City of Biddeford
Planning Board
July 01, 2020 6:00 PM Via ZOOM

Planning Board MINUTES (DRAFT)

PLANNING BOARD REPORT

PLANNING BOARD REPORT

Atlantic Resource Consultants
541 US Route One
Freeport, ME 04032
Tel: 207.869.9050
DRAWN: MPV
DESIGNED: JAV
CHECKED: JAV
FILE NAME:
SHEET: C-301

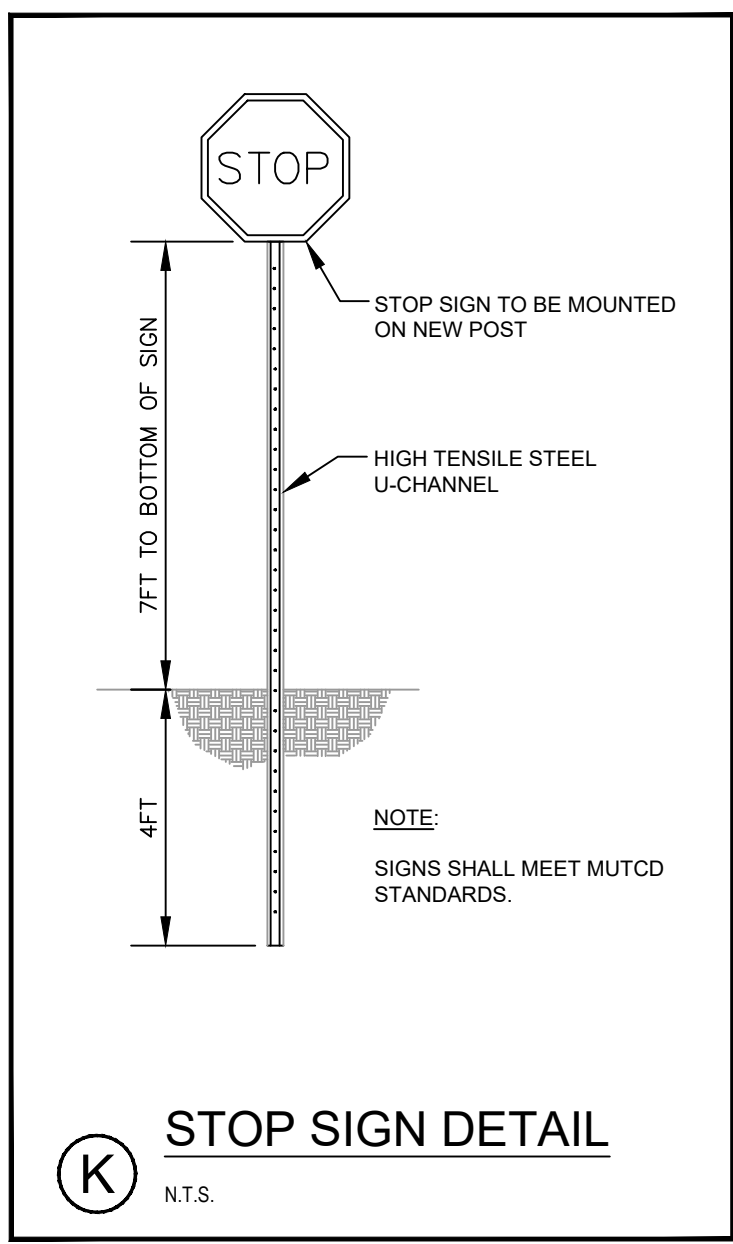
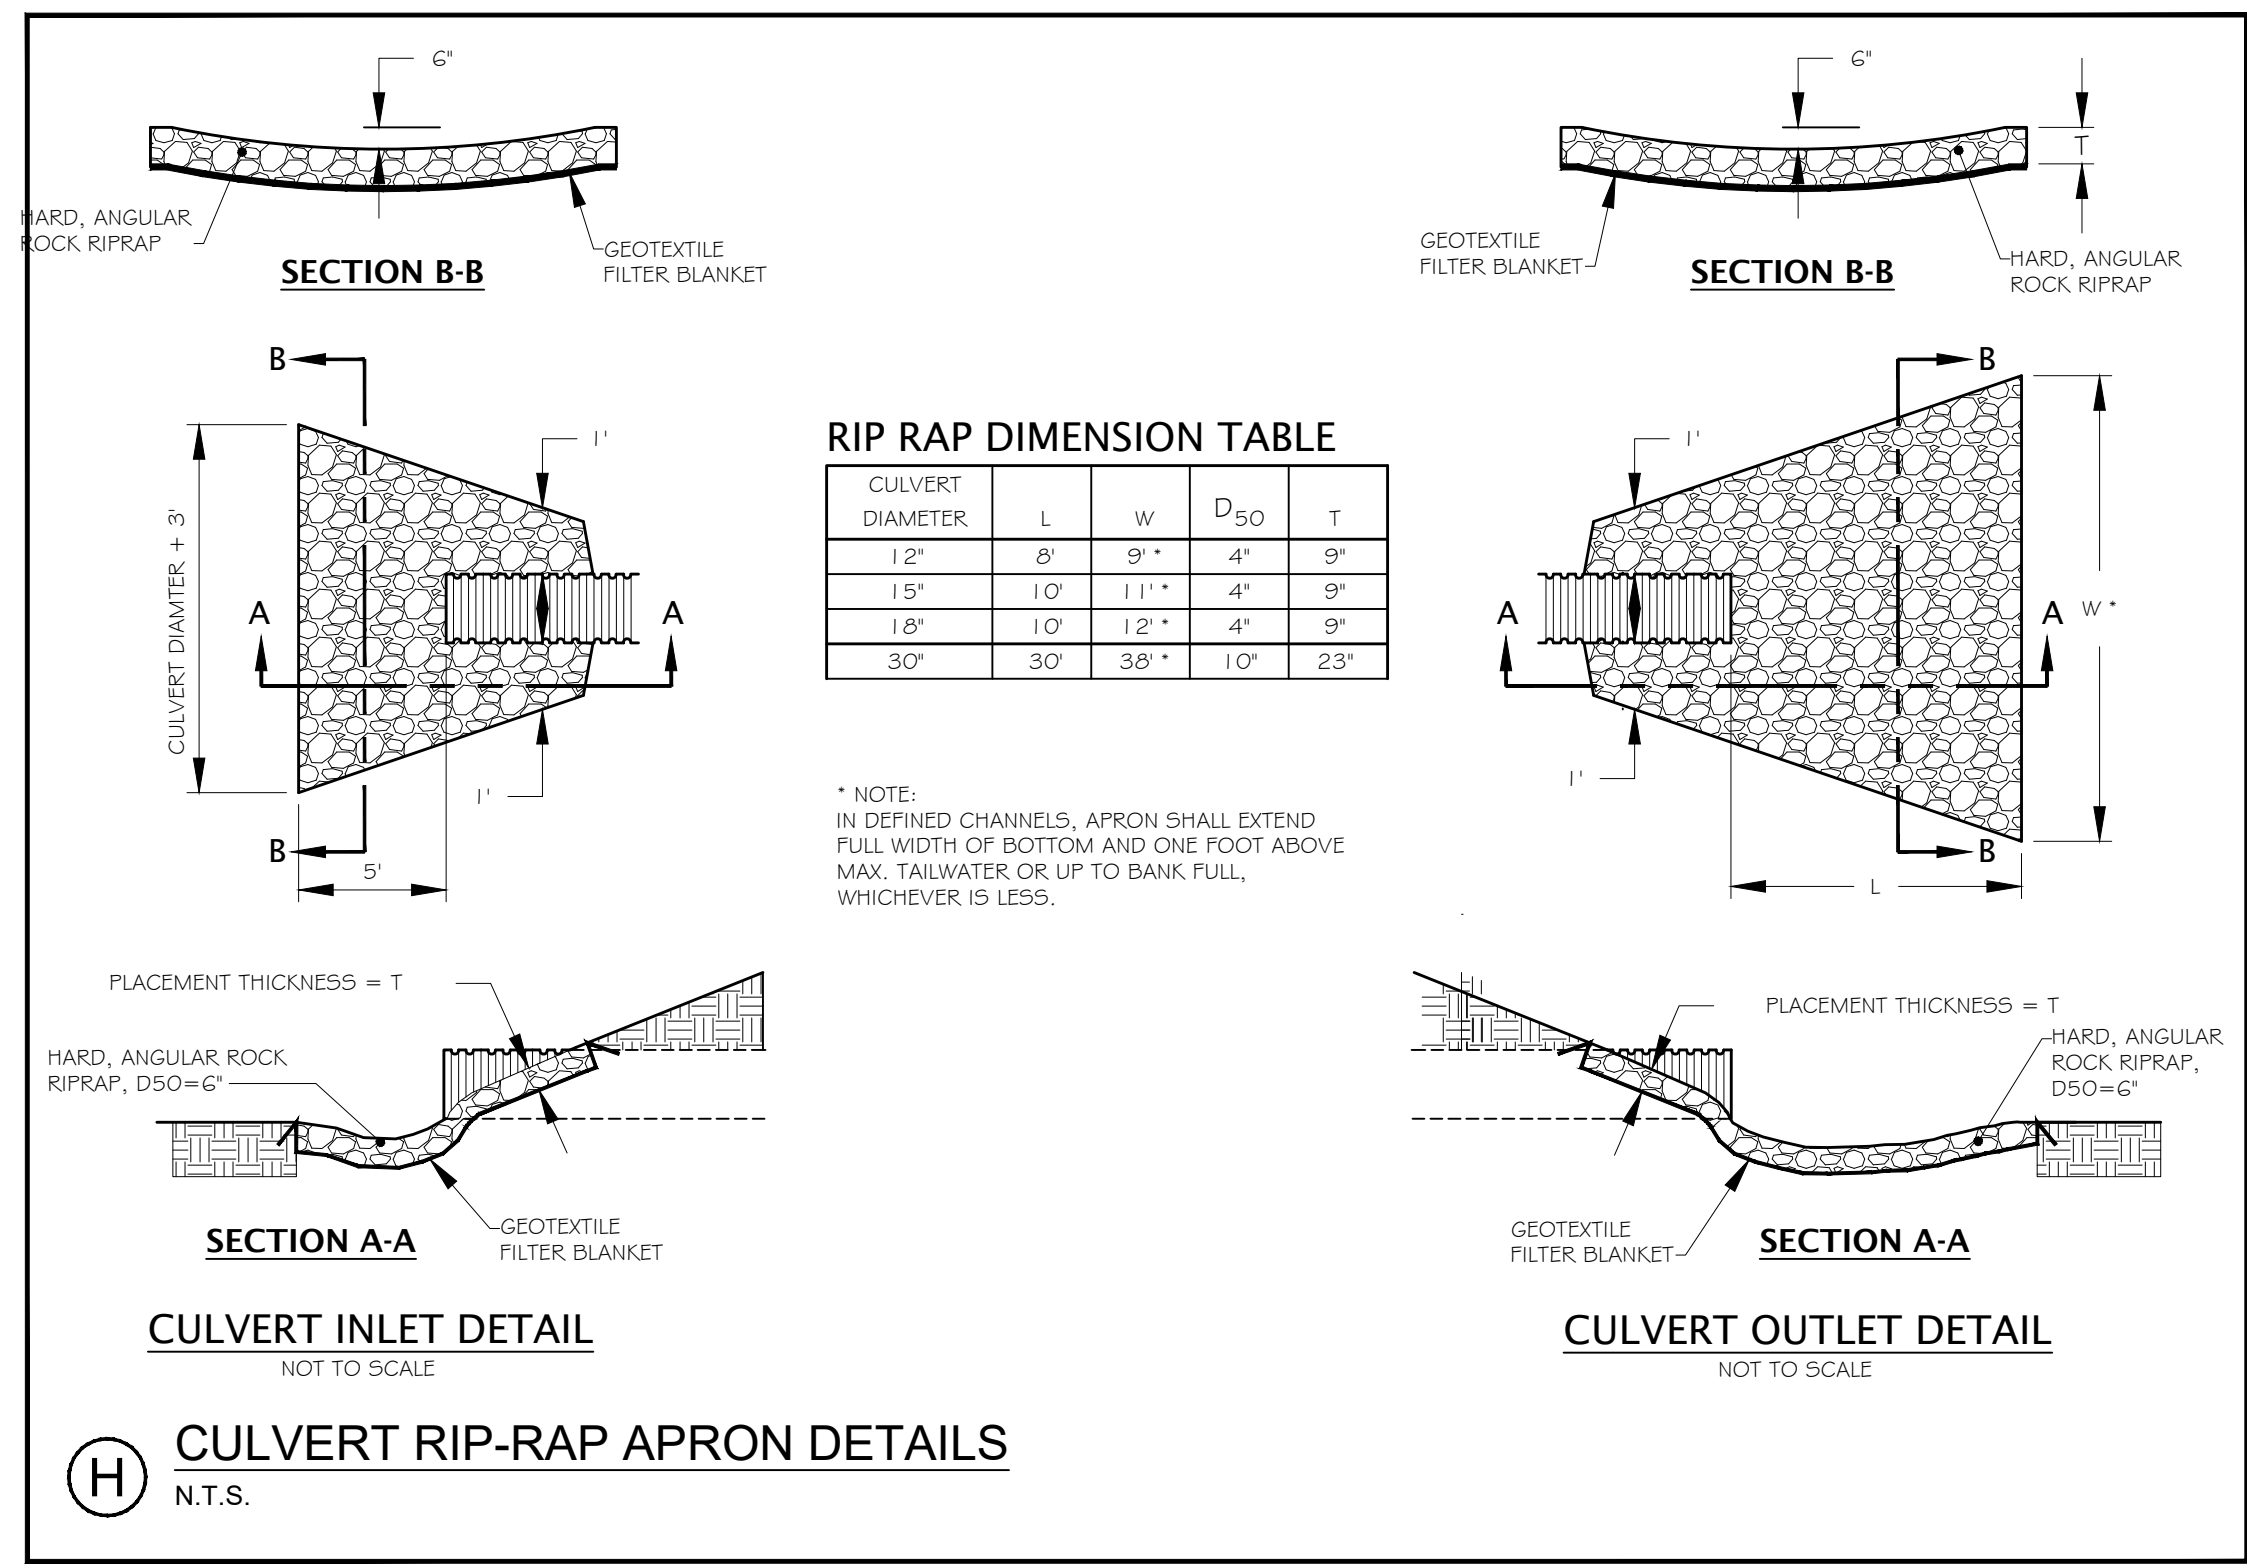
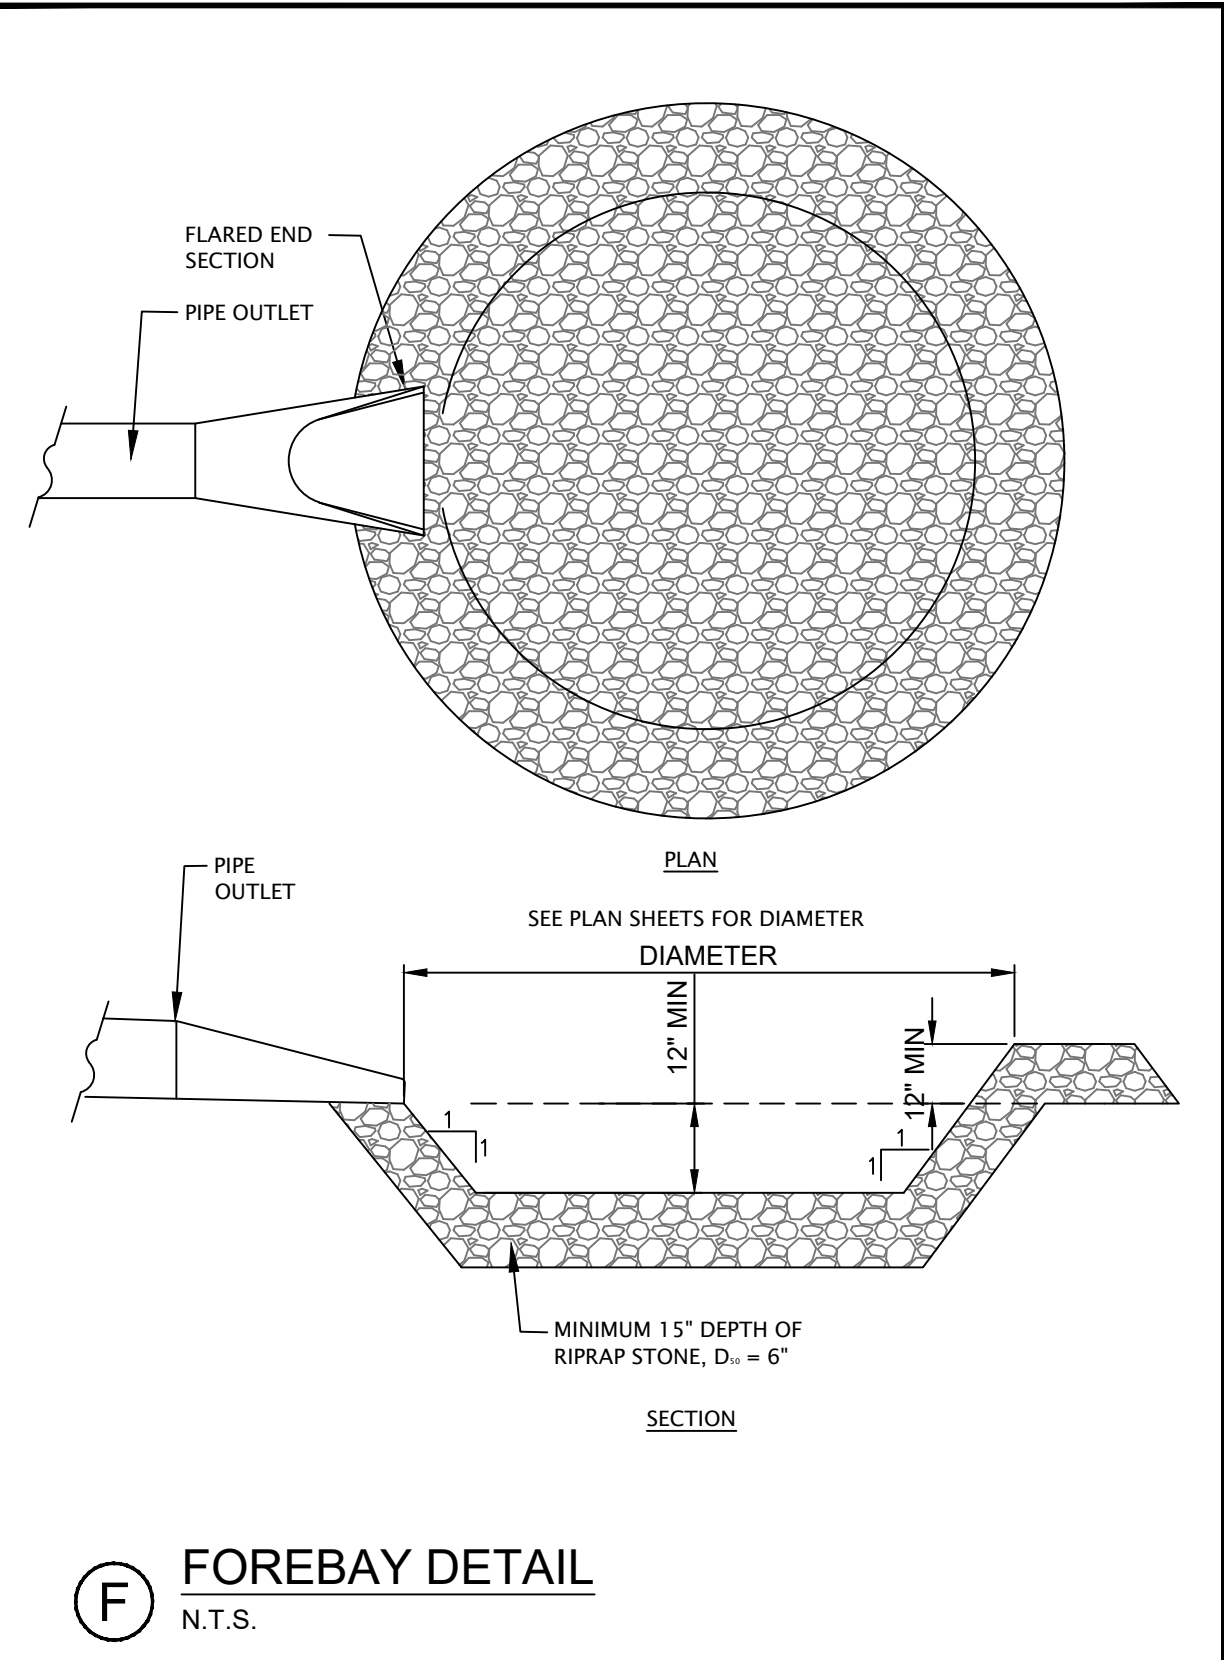
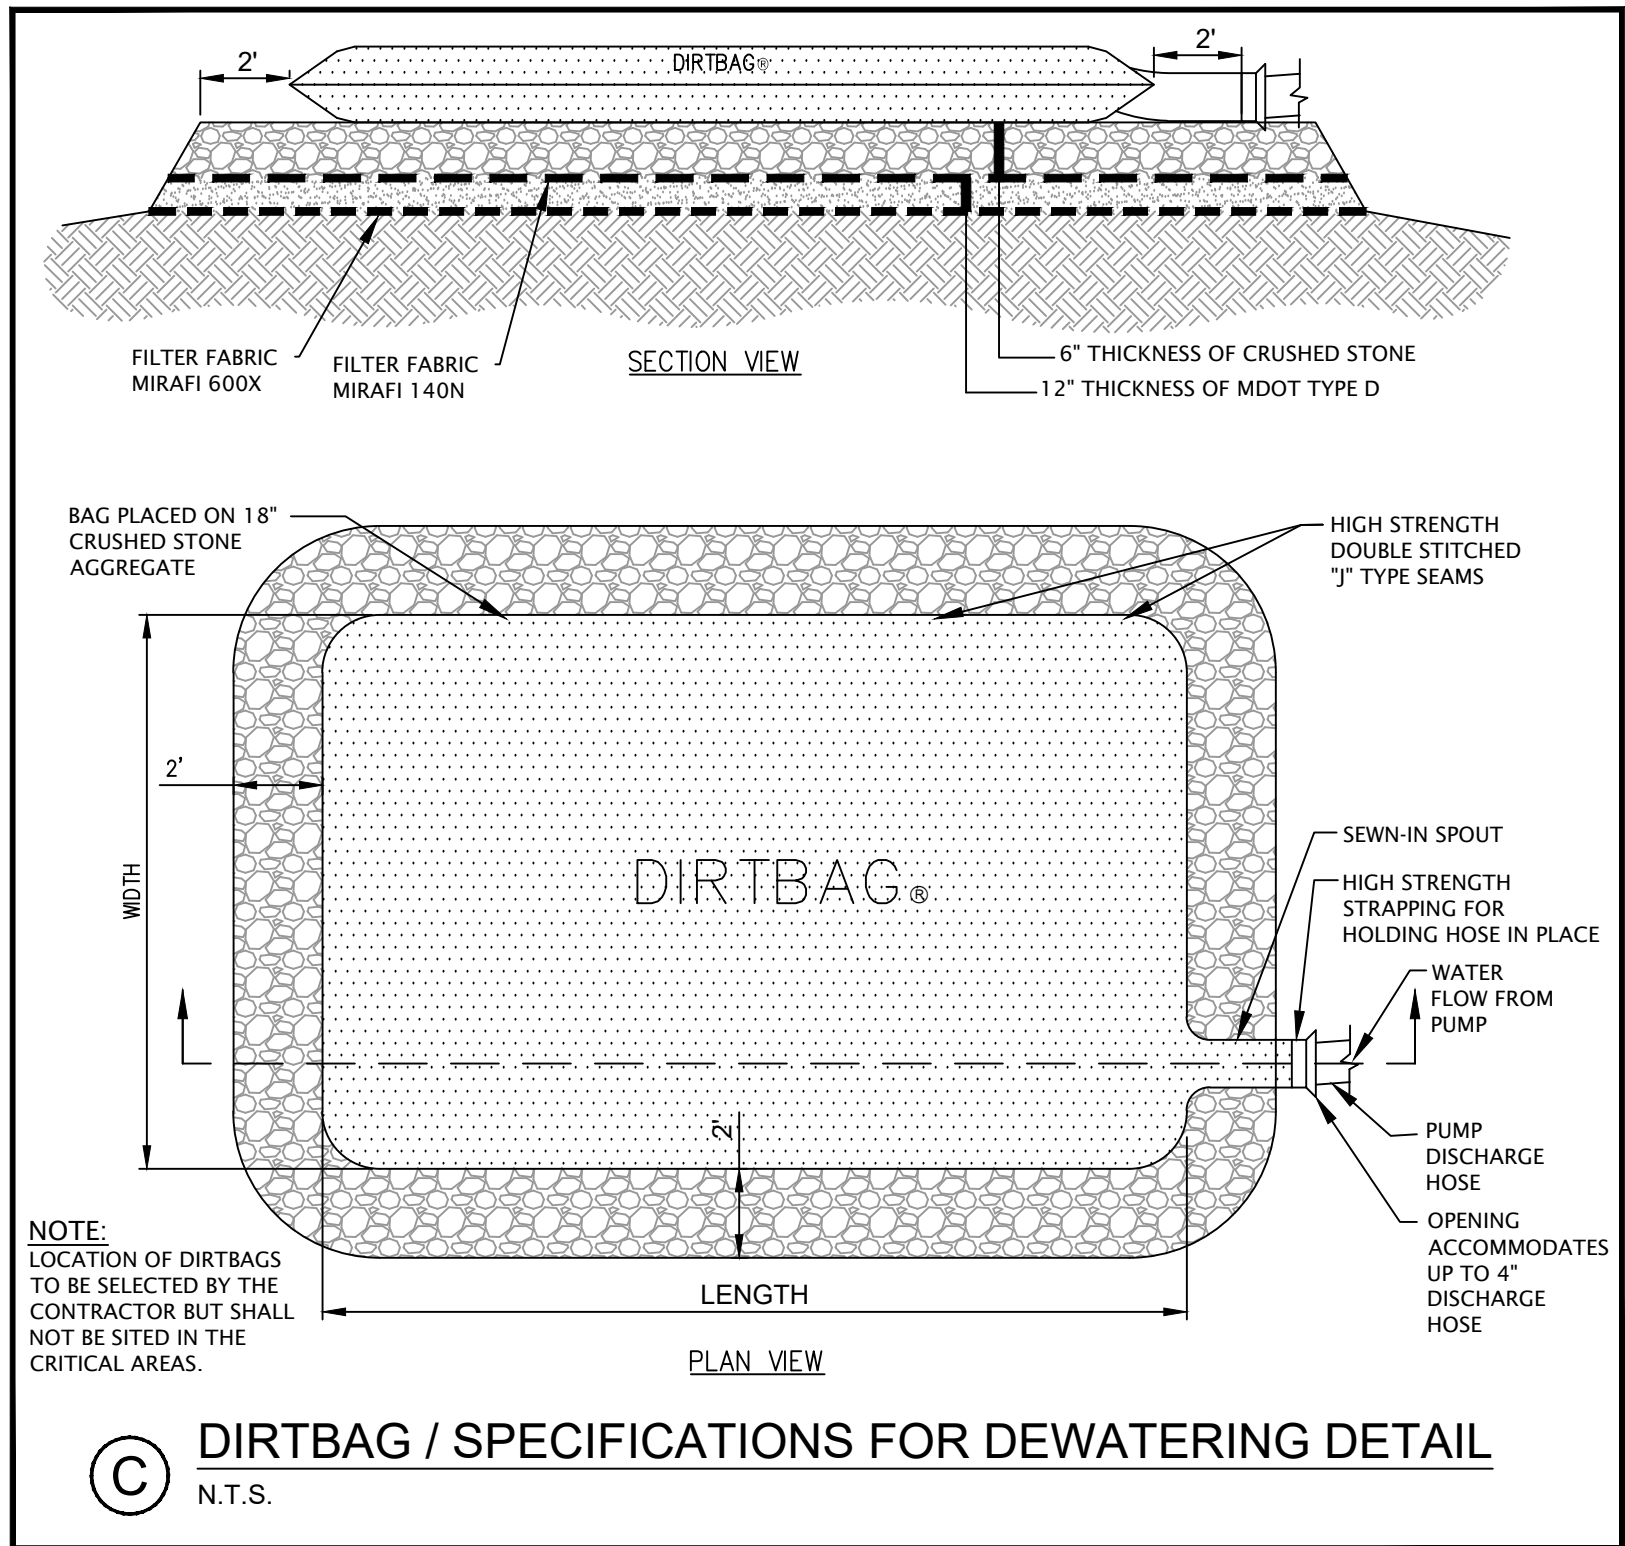
- Addressed.
 - Addressed.
 - Addressed.
 - The riprap apron table shown on drawing C-301 should include dimensions associated with a 24 inch diameter pipe.
